Technical change to 1250370000 LSF-SMD 3.50/03/180 SN BK RL

the products of 1250370000 will be changed.

Old version	New version

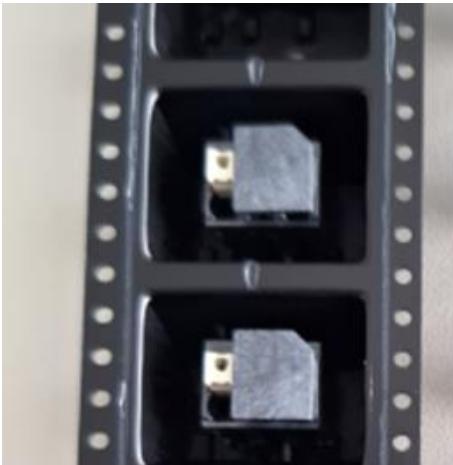
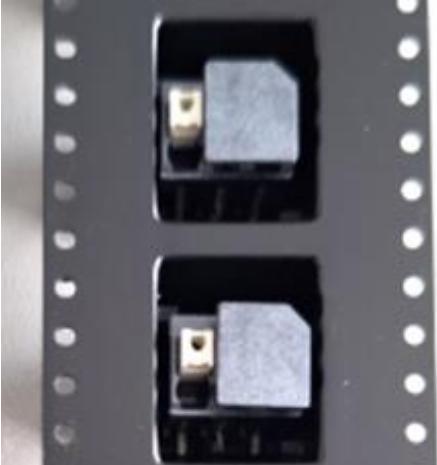
The new tape improves the ability to hold the article in place and prevents it from slipping.

The new tape has the same outer dimensions and the same distances between the articles as the old tape. Only the inner geometry of the tape pocket in which the article is located has become smaller. The relevant dimensions for removing the article out of the tape have not changed.
